**The Project for
Improvement of Road Technology
in Disaster Affected Area in Myanmar**

**Technical Note on National Highway
& Expressway**

(Geometric Structure & Traffic Safety Facility)

June 2015

Action Outcome of the CP

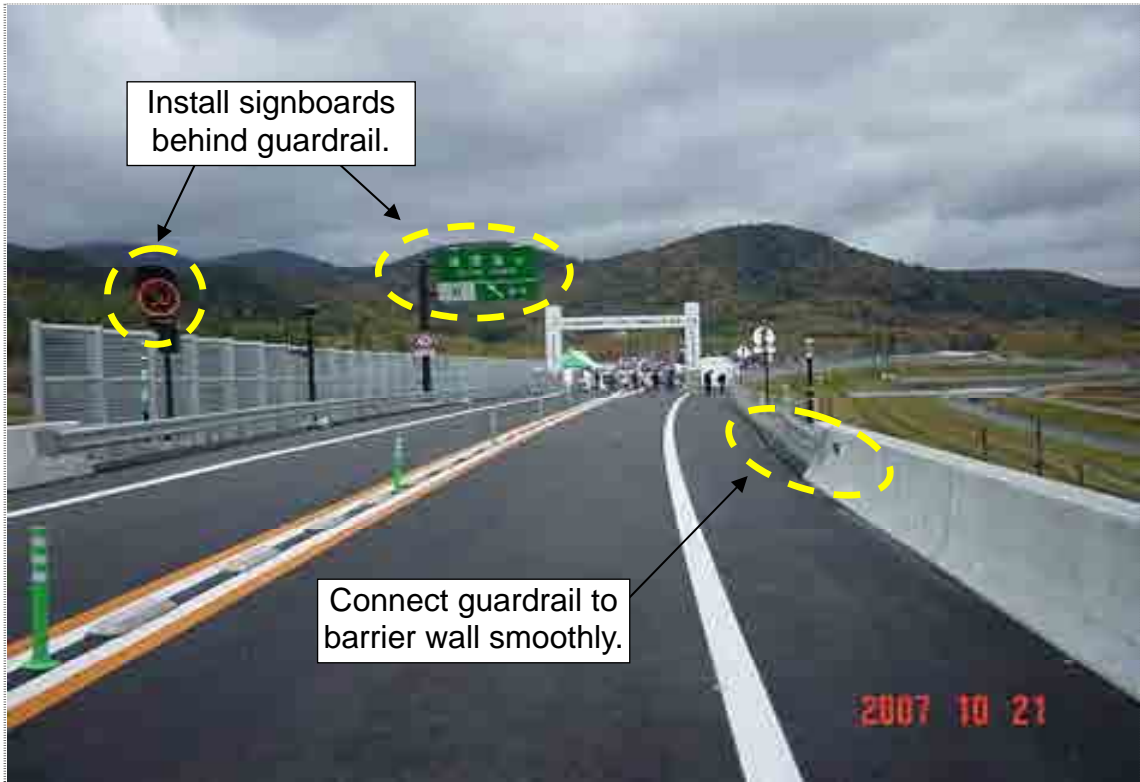
The counterpart (CP) of the Government of Myanmar took swift action to solve the issues in response to the discussion with the Team as shown in the following figure.

Figure 1.3.3 Examples of Proposals for the Solution

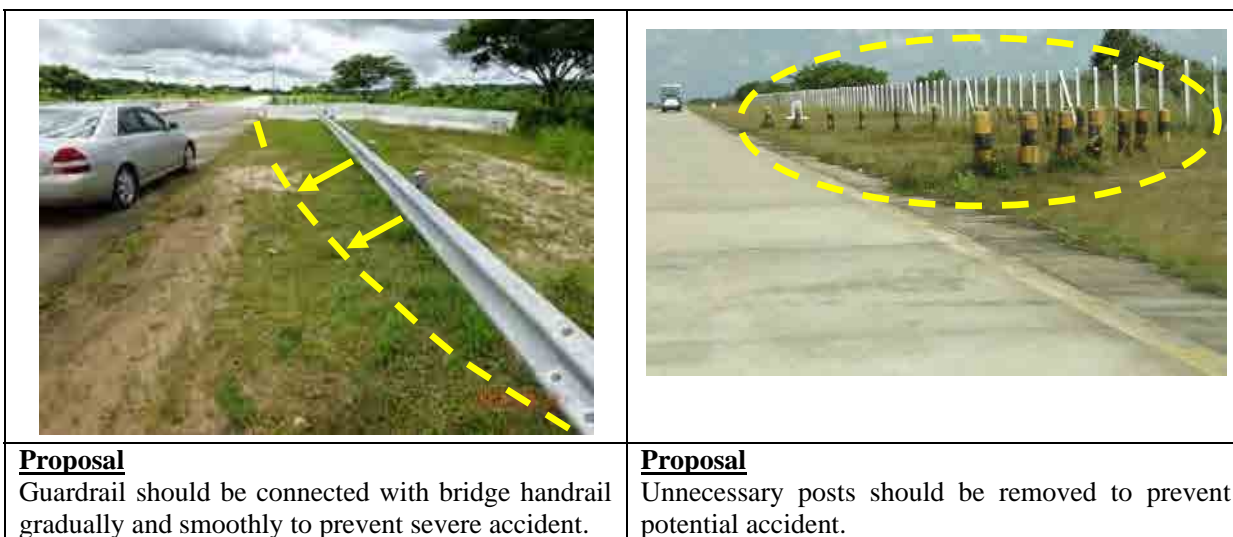
The Team finalized and compiled proposal for solution on the basis of the above works. Examples of the proposal are as shown in Figure 1.3.3.

Figure 2.4.1 Action Outcome of the CP

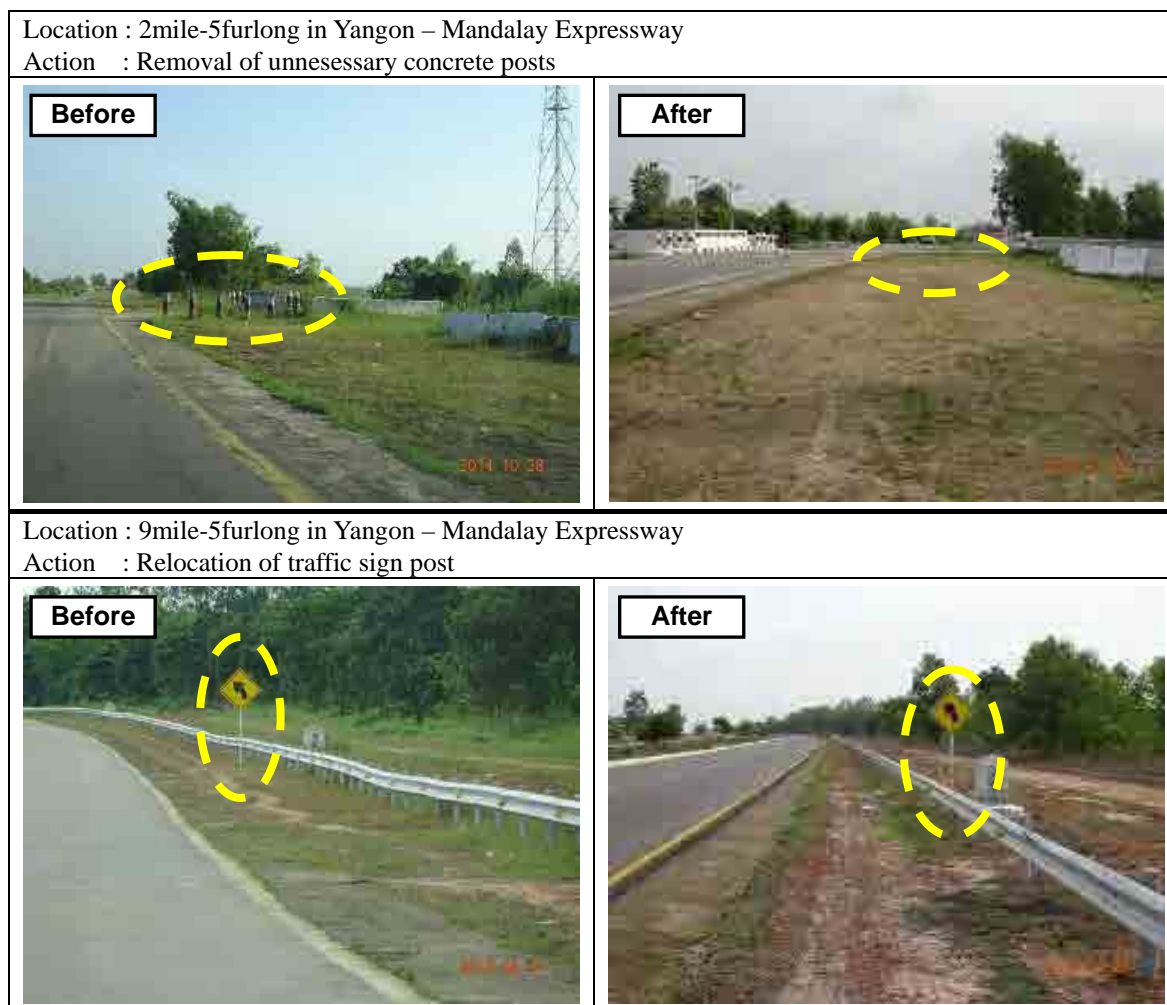
The Team had fruitful discussion with the counterpart (CP) appointed by the Government of Myanmar to deal with the issues identified through the site investigation. Subsequently, CP took swift action to solve the issues such as mainly for issue (1) and (2). Photos of the action outcome are illustrated in Figure 2.4.1. Furthermore, checklist of the action taken by CP (latest version: Jun/2015) is as shown in Table 2.4.1. The Team expects sustainable implementation of the action a lot in a future.

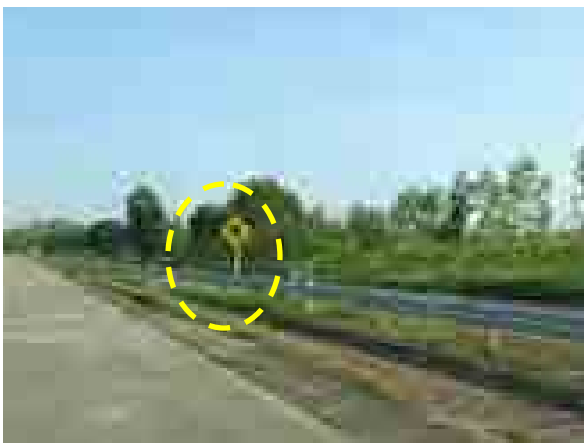
Ph.139 Concrete curb was set back to median strip side to secure shoulder width (good action).

Ph.140 But concrete wall also should be set back.
